Florida Department of Environmental Protection

November 19, 2008

Re: Electrical Resistance Heating (ERH)

The Division of Waste Management (the Division) hereby accepts Electrical Resistance Heating (ERH) by Thermal Remediation Systems Incorporated as a technology for in situ remediation of petroleum, chlorinated hydrocarbons and other suitable contaminants in groundwater and soil. There are no objections to the use of ERH for the remediation of contaminated sites in Florida, provided a site-specific Remedial Action Plan is approved by the Department. Regulatory information is provided in Enclosure 1, and supplemental information in Enclosure 2.

Figure 1. Block diagram of the Electrical Resistance Heating (ERH) process.

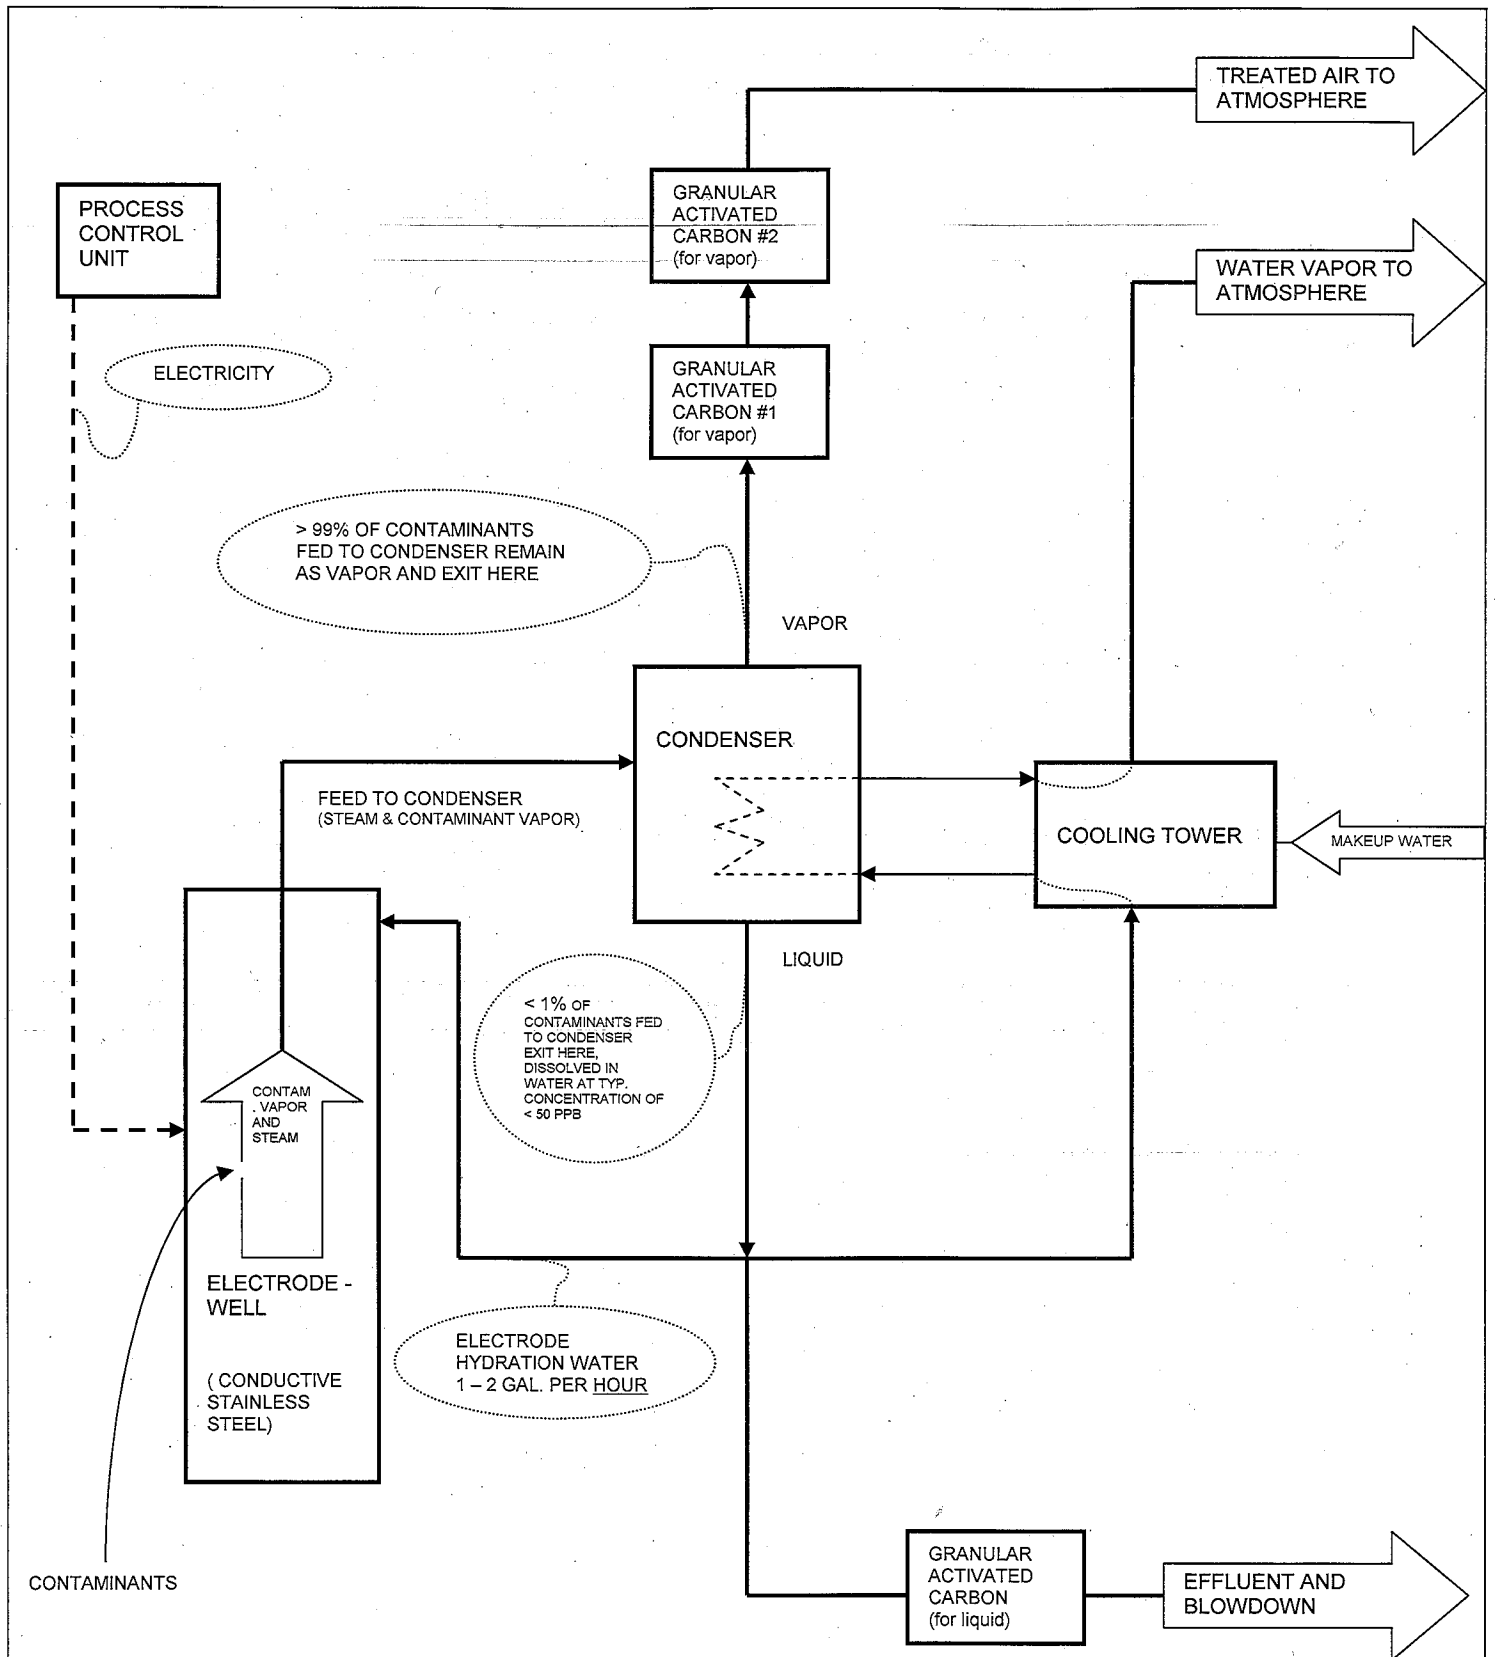
In Figure 1, the bulk of the liquid from the condenser is sent to a cooling tower, where most of it evaporates. A small portion is used as drip water to keep the vadose moist at the electrodes. The remainder of the condensate is discharged as effluent or as blowdown to prevent scaling in the condenser due to an accumulation of dissolved solids. Thermal Remediation Systems indicates that the amount of contaminants in the vapor stream exiting the condenser is typically 99% or more of that which enters. The balance exits with the condensate at a typical concentration of 50 parts per billion or less.
